Issue Date	Rev	Description	Drawn	Checked
15/09/2016	A	ISSUED FOR DEVELOPMENT APPLICATION	DVI	LT
07/02/2017	B	DEFERRED COMMENCEMENT - DA AMENDMENTS	DVI	LT
13/03/2017	C	SECTION 96 - LIGHTWELL	DVI	LT
24/05/2019	D	SECTION 96	DVI	LT
APRIL 2020	F	REVISED SECTION 96	DVI	LT

PROJECT	
GARLING HOUSE PROPOSED NEW RESIDENCE 24 LANCASTER CRESCENT, COLLAROY NSW LOT 3 DP.11899	
FOR MR & MRS GARLING

DRAWING TITLE	
PLANS SITE PLAN	
SCALE 1:200, 1:100 @ A2	DRAWN BY LT/DVI
PROJECT NO. 1612	PLOT DATE 9/04/2020
	REVISION
	DA-01 F

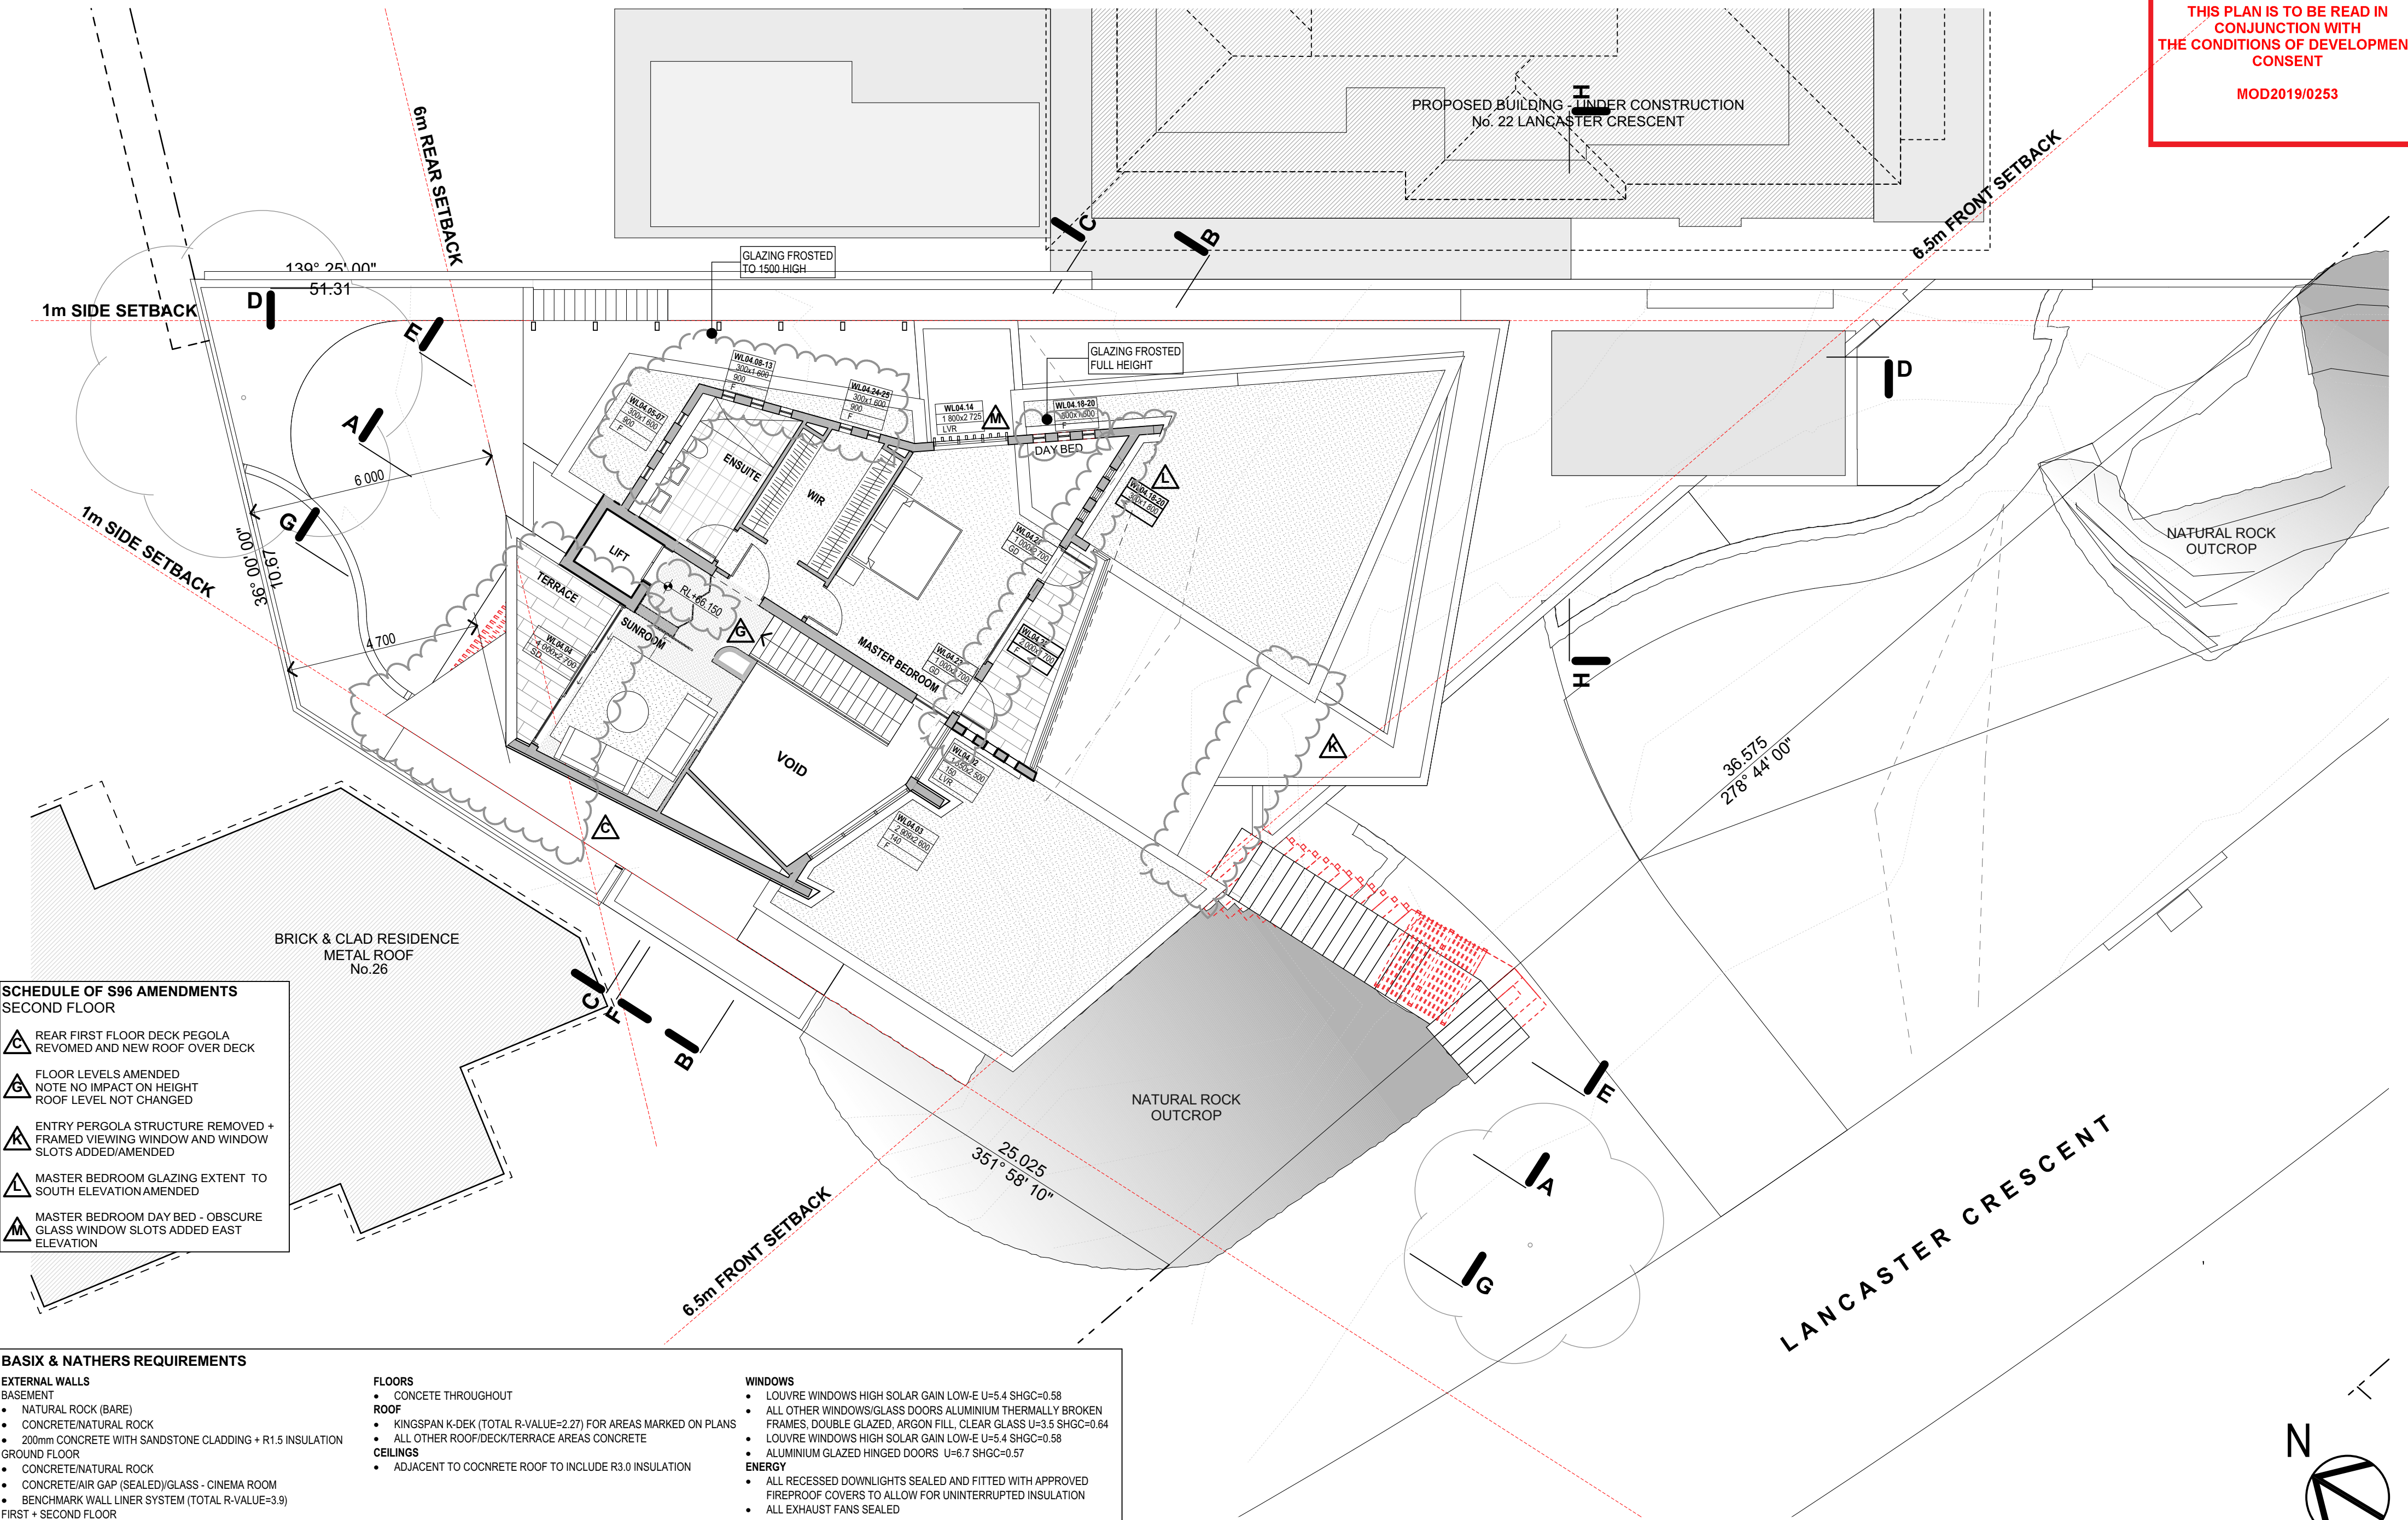
SCHEDULE OF S96 AMENDMENTS SECOND FLOOR	
	REAR FIRST FLOOR DECK PEGOLA REVOMED AND NEW ROOF OVER DECK
	FLOOR LEVELS AMENDED NOTE NO IMPACT ON HEIGHT ROOF LEVEL NOT CHANGED
	ENTRY PERGOLA STRUCTURE REMOVED + FRAMED VIEWING WINDOW AND WINDOW SLOTS ADDED/AMENDED
	MASTER BEDROOM GLAZING EXTENT TO SOUTH ELEVATION AMENDED
	MASTER BEDROOM DAY BED - OBSCURE GLASS WINDOW SLOTS ADDED EAST ELEVATION

DRAWING TITLE
ELEVATIONS
SOUTH + WEST

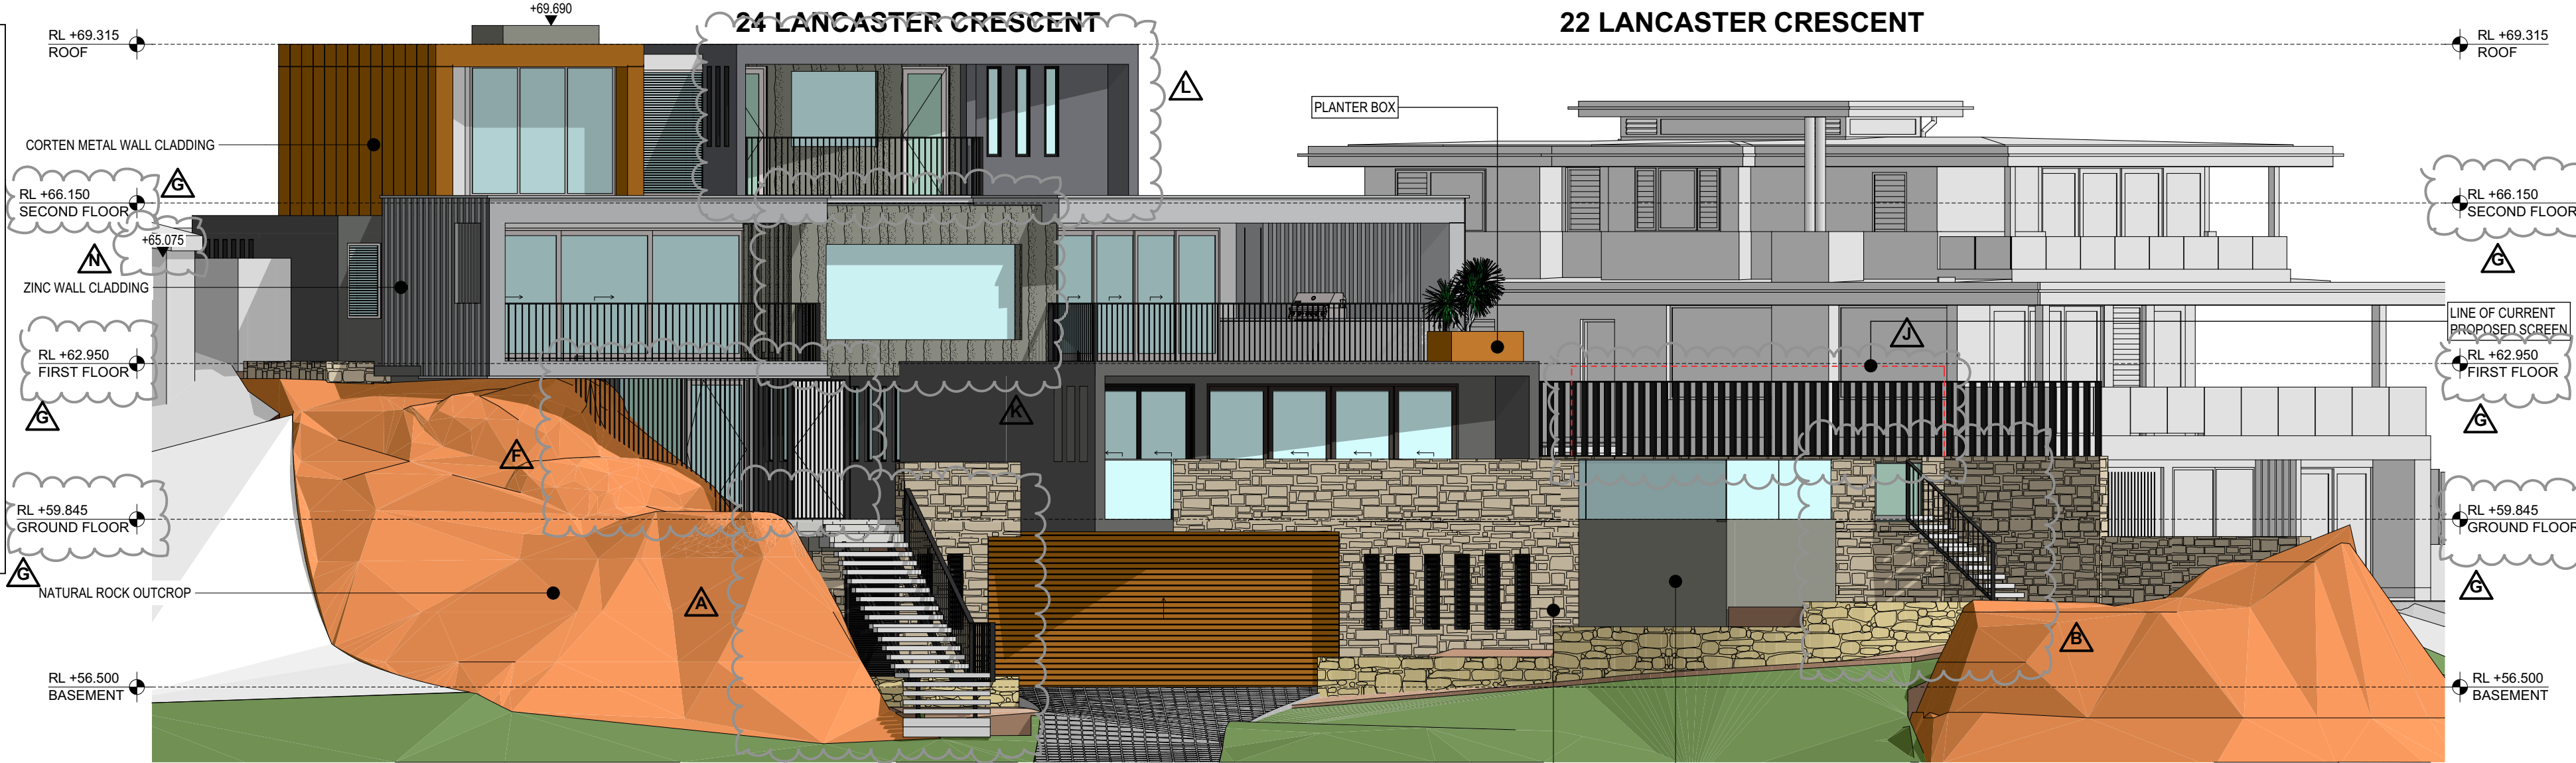
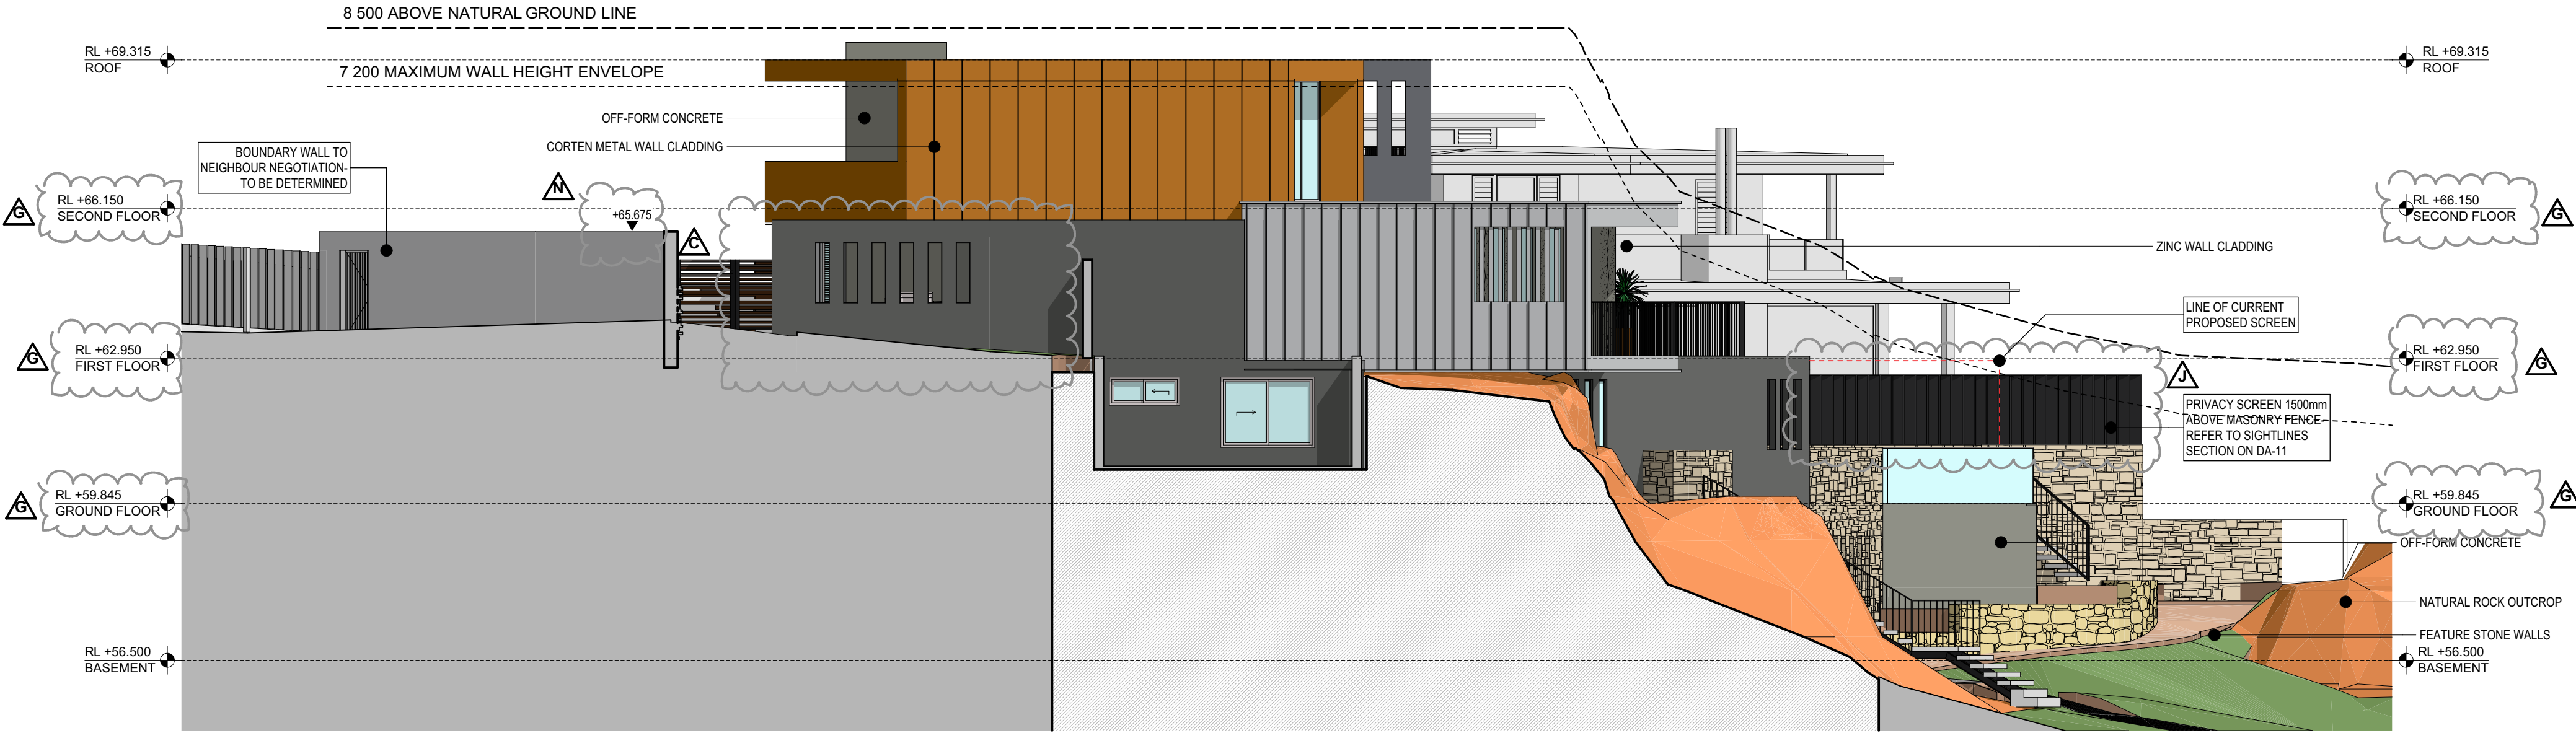
SCHEDULE OF S96 AMENDMENTS
SOUTH + WEST ELEVATIONS

- ACCESS GATE AND STAIR FROM POOL ENCLOSURE TO ALLOW ACCESS TO STREET FRONT LANDSCAPE AREA
- STREET FRONT ACCESS STAIR AMENDED TO SUIT ROCK FACE AND ENTRY STURCTURE REMOVED
- REAR FIRST FLOOR DECK PEGOLA REVOMED AND NEW ROOF OVER DECK
- FRONT ENTRY GATE + VESTIBULE AND POND ADDED
- FLOOR LEVELS AMENDED
NOTE NO IMPACT ON HEIGHT
ROOF LEVEL NOT CHANGED
- BOUNDARY POOL PRIVACY SCREEN ADDED TO TOP OF WALL - 1500 HIGH REFER SECTION ON DA-11
- ENTRY PERGOLA STRUCTURE REMOVED + FRAMED VIEWING WINDOW AND WINDOW SLOTS ADDED/AMENDED
- MASTER BEDROOM GLAZING EXTENT TO SOUTH ELEVATION AMENDED
- BOUNDARY FENCE LEVEL ADDED
